HVAC FLOOR PLAN
BLDG 13
SKYLINE COLLEGE SWING SPACE
PERMIT PACKAGE #3
SKYLINE COLLEGE
3300 COLLEGE DRIVE
SAN BRUNO, CA 94066

HVAC FLOOR PLAN

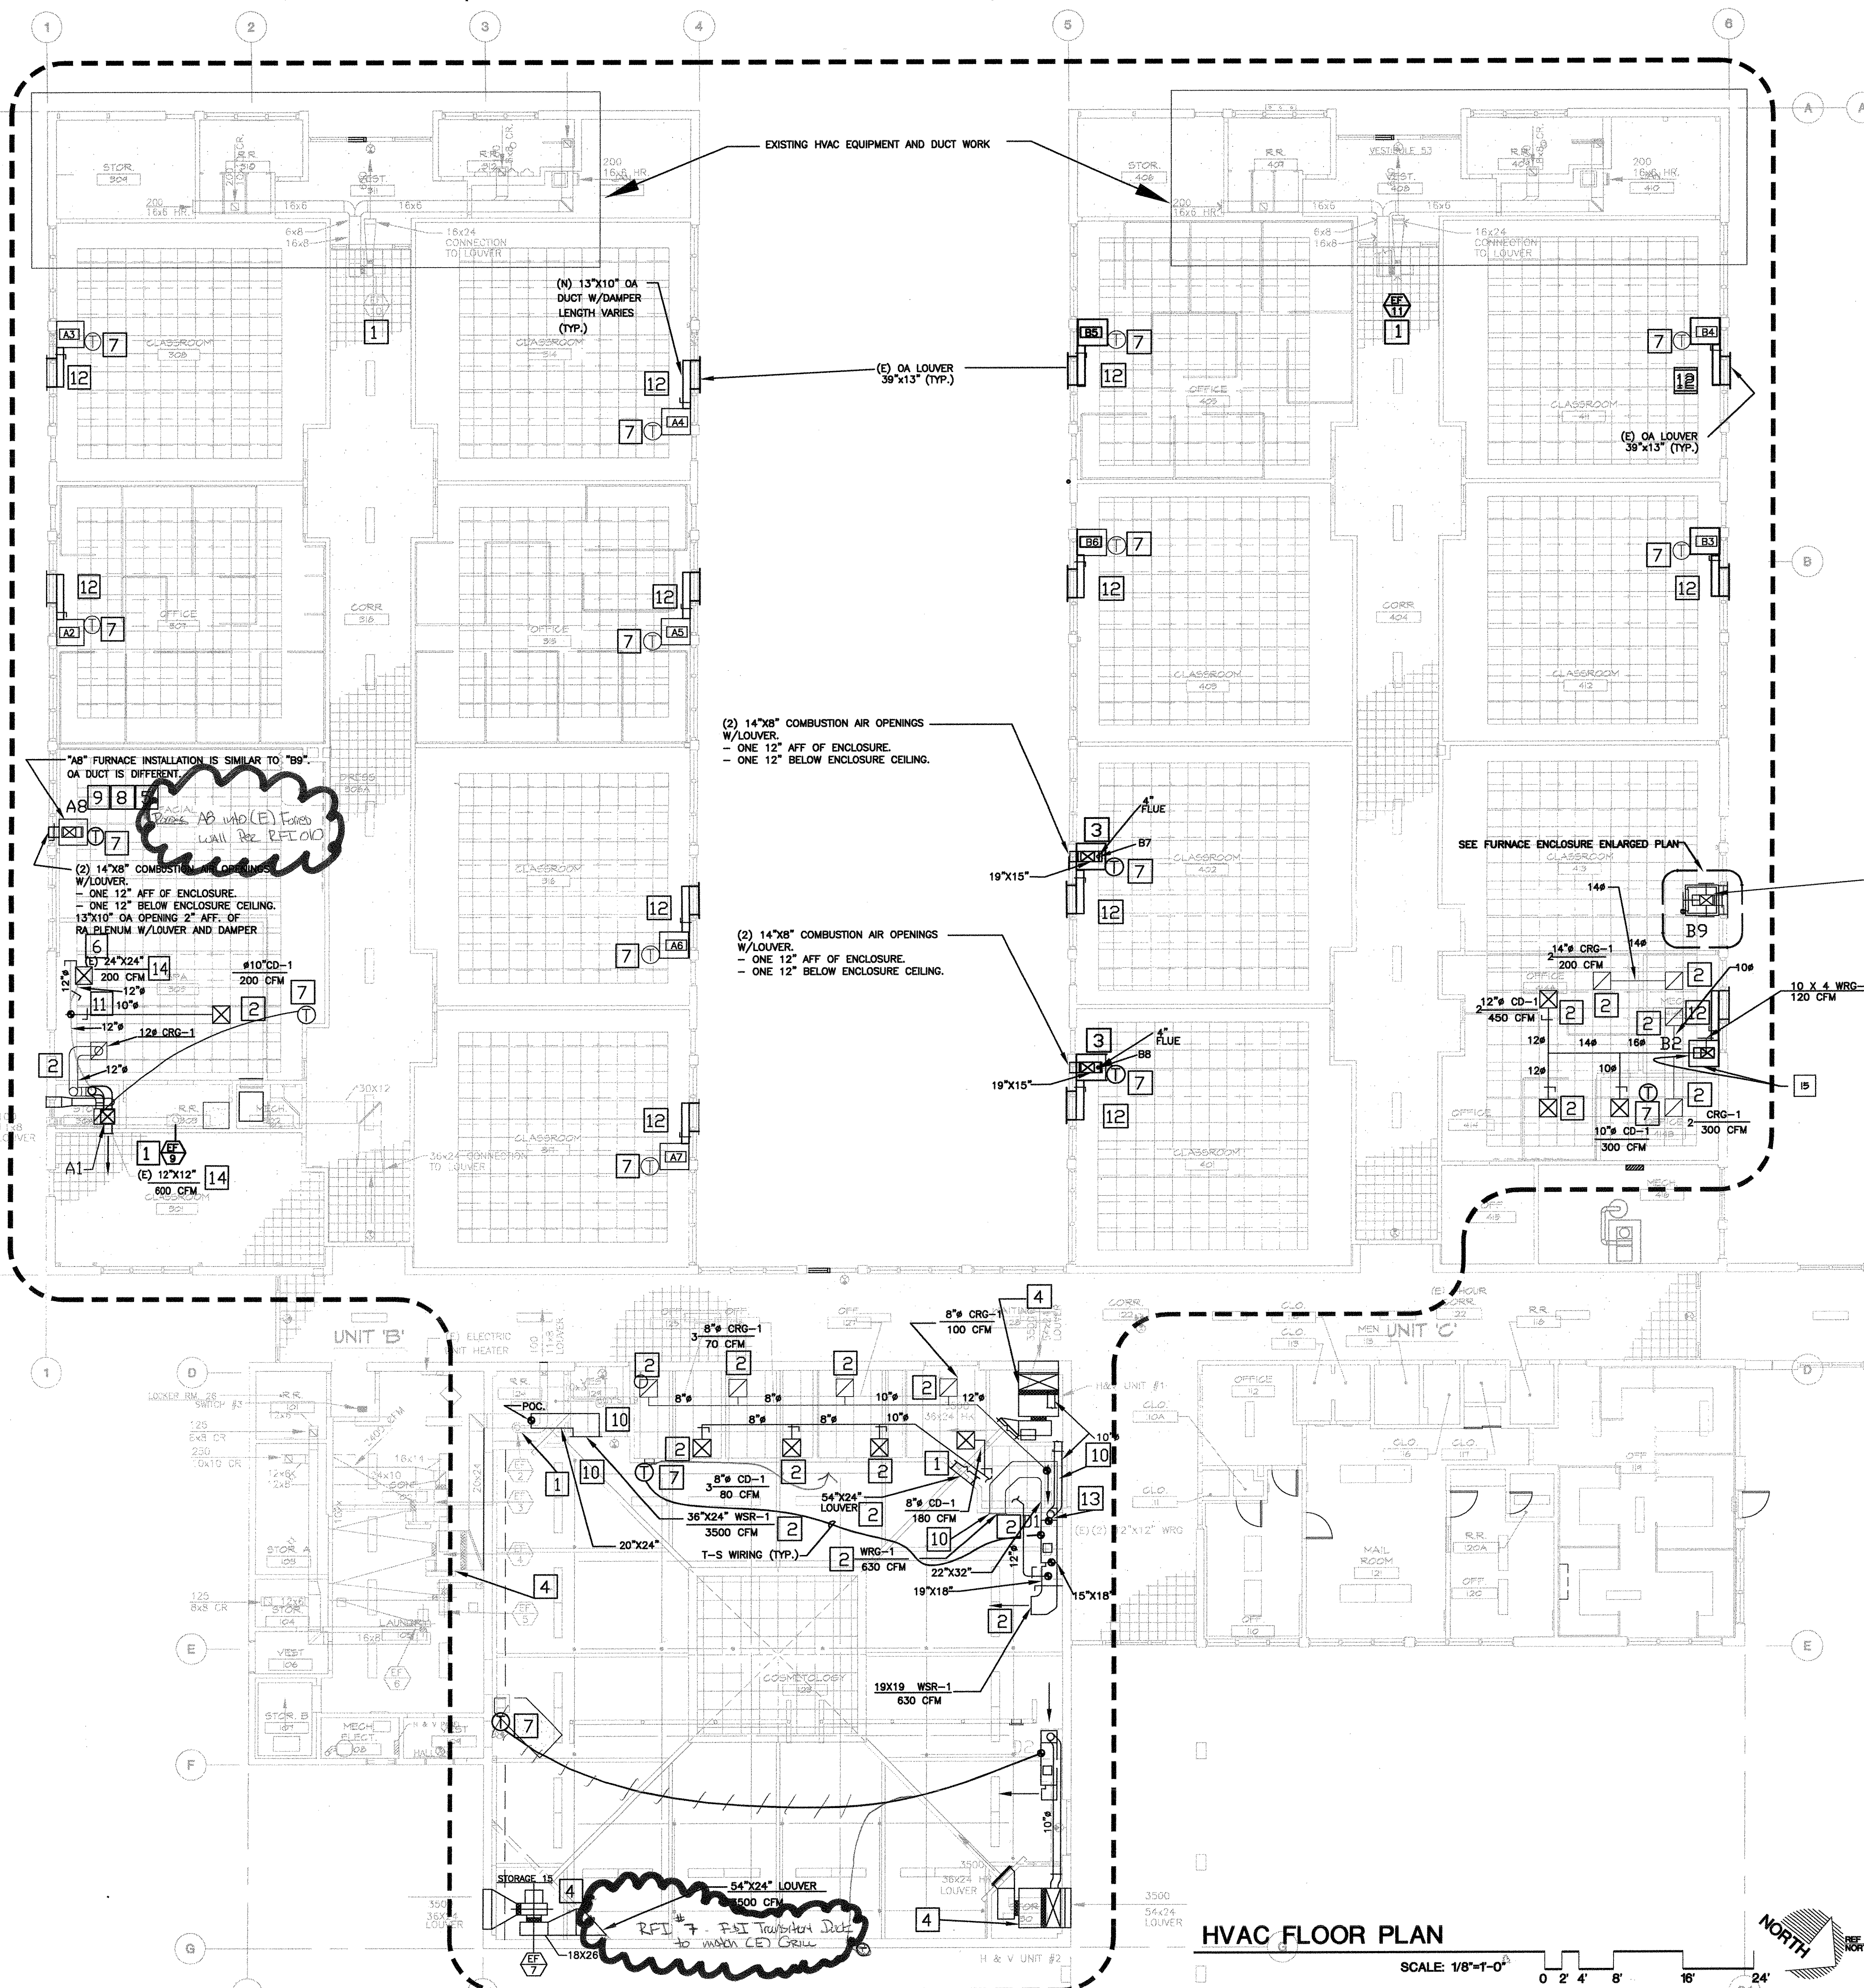
RFI #2 Fabricate & Drawshop to check CE) utilities

RFI #7 Fabricate & Drawshop to check CE) utilities
